## Product Advisory: A134

**Description:** Flamgard Plus, TXgard Plus

**Issue:** Alarm Relay 2 Fault

Flamgard Plus & TXgard Plus Relay Module

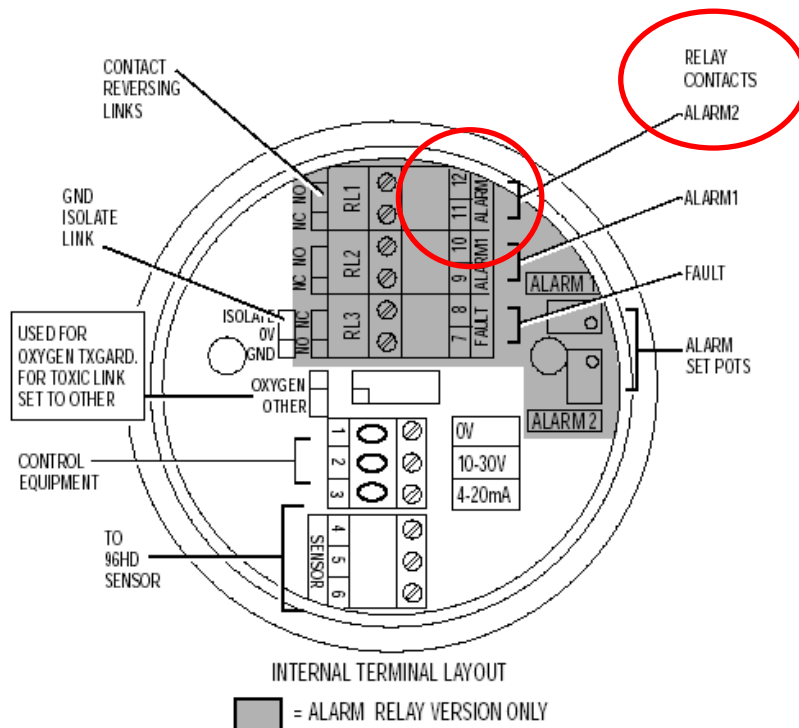
A small number of detectors have failed commissioning tests due to the Alarm 2 relay not activating. The issue has been traced to a faulty component on the circuit board which should have been identified during the testing processes in the Crowcon production facility. Alarm 1 and Fault relays operate correctly. In this instance the status LED operates correctly; flashing red when the Alarm 2 threshold is breached and suggesting the relay has activated. It is essential therefore to verify the relay is operational.

Alarm 2 relay operation can be verified by checking the contact opens/closes at terminals 11/12 when the gas reading exceeds the alarm threshold. Correct activation of alarms and/or shutdowns is sufficient to prove the relay is operating correctly.

We advise that all detectors fitted with relays are tested on receipt of this notice, and if any relay failures are noted contact Crowcon as shown below.
